V2500-A5 SERIES PROPULSION SYSTEMS NON-MODIFICATION SERVICE BULLETIN

This document transmits Revision 7 to Service Bulletin EV2500-72-0386

ENGINE – LP COMPRESSOR FAN BLADES – DOVETAIL ROOT FLANK ULTRASONIC INSPECTION AND
APPLICATION OF DRY FILM LUBRICANT (ROOT FRETTING/WEAR – SCARRING) NON-MODIFICATION
SERVICE BULLETIN

Schematic diagram showing position of probe on blade root flank
Fig.2

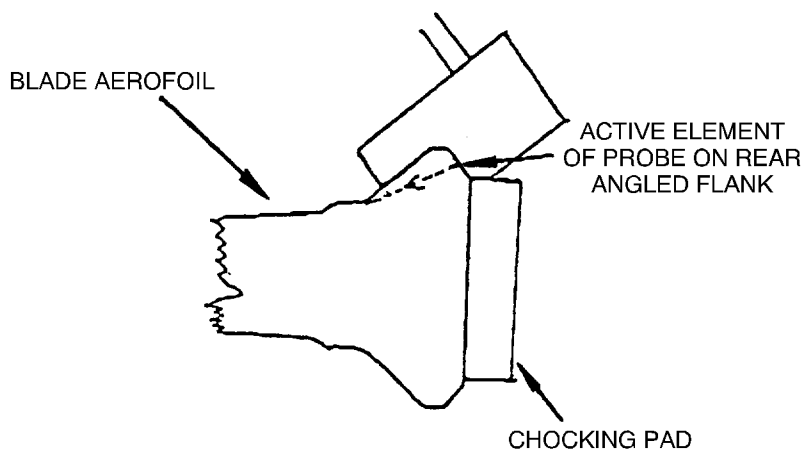
- (3) Do an ultrasonic inspection on each of the fan blades.
 - (a) Apply the couplant to the concave face of the blade root flank at the area to be inspected. Position the probe at the front of the leading edge of the concave blade root flank and move the probe along the first 2.4in. (60 mm.) of the chordal width of the blade root. (Refer to Fig. 2).

- (d) Apply the couplant to the convex face of the blade root flank at the area to be inspected. Position the probe at 1.77in. (45 mm.) from the front face of the blade root (immediately behind the front chocking pad, if still installed) and move the probe along the next 4.33in. (110 mm.) of the chordal width of the blade root, terminating the inspection at 6.10in. (155 mm.) from the front face of the blade root (approximately 3.3in. (85 mm.) from the rear face of the root).

Removal of excess Dry Film Lubricant (DFL)
Fig.3

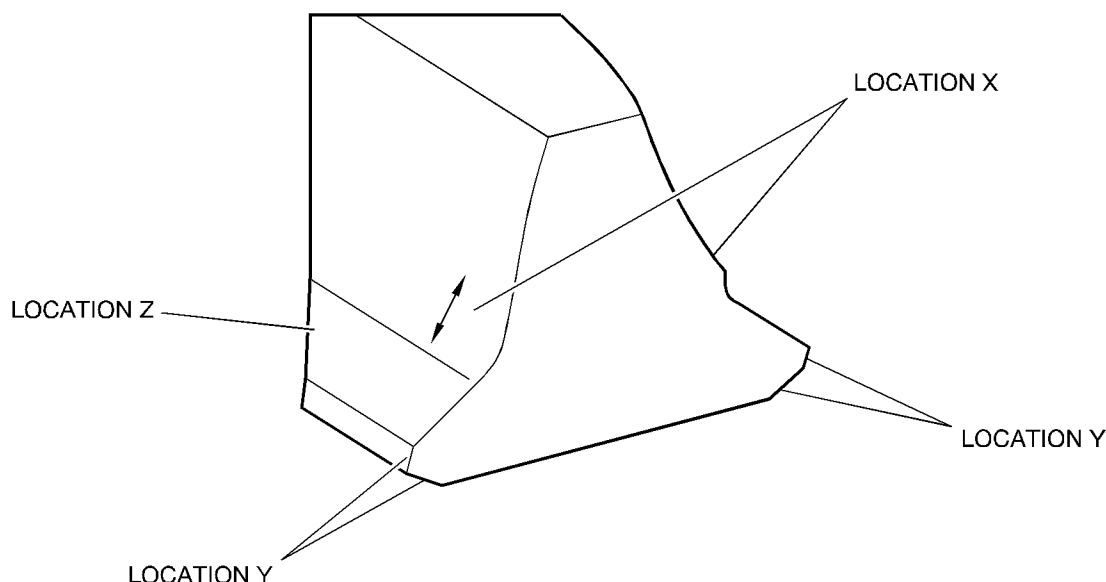
- 1) At the ultrasonic reject indication locations, on either the concave or the convex flanks, remove any excess Dry Film Lubricant (DFL) by lightly rubbing with 'Scotchbrite' using CoMat No 05-125 to 05-127 in the following areas:
 - above the top edge of the bedding (location X)
 - at the lower corner of the root where the ultrasonic probe locates (location Y)

CAUTION 1: On post SB 72-0375 and post SB72-0384 (Metco 58 coated root) fan blades it is essential not to "scotchbrite" the fan blade bedding surface (Location Z) as this will have a detrimental effect to the coating.

- 2) If excessive DFL is present, at location X and/or Y that cannot be removed by lightly rubbing with 'Scotchbrite' it is permissible to remove this using a non metallic scraper and then remove any loose residual DFL using 'Scotchbrite'

CAUTION 2: On post SB 72-0375 and post SB72-0384 (Metco 58 coated root) fan blades it is important not to damage the fan blade bedding surface (Location Z) when using a scraper

Inspection areas
Appendix 2, Fig.1

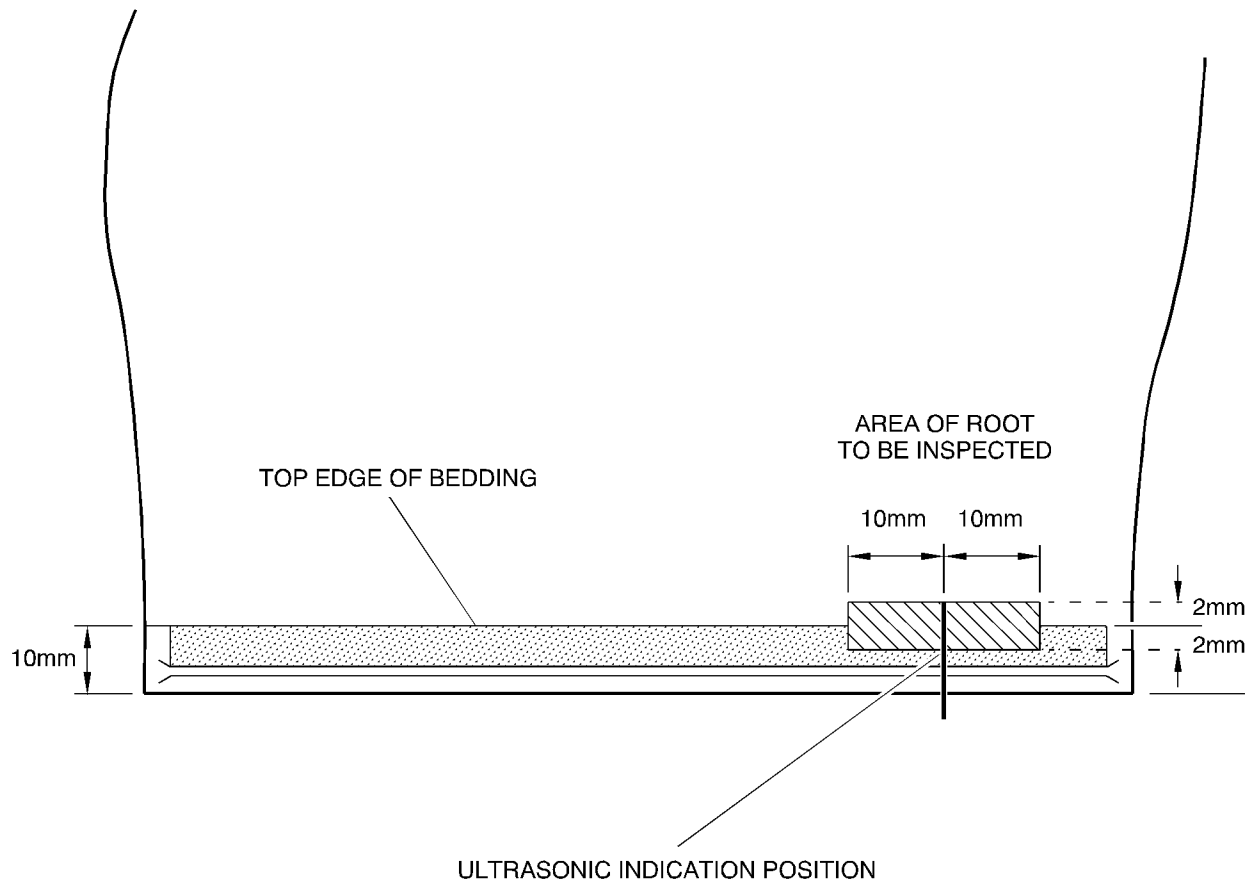
(2) Adjust lamp to optimum position for highlighting top edge of bedding at ultrasonic indication position, as illustrated in Appendix 2, Figure 1.

(4) Slowly traverse along the blade, inspecting the top edge of bedding 10 mm. either side of the ultrasonic indication position, as shown in Appendix 2, Figure 1.

NOTE: The inspection should cover the area approximately 2 mm. above and below the top edge of bedding. Re-focus the binocular and adjust the lamp as required.

(1) Reject any blade exhibiting a crack-like feature running axially along the root in the inspected region.

(2) Reject any blade exhibiting a 'scar' or crater-like feature.
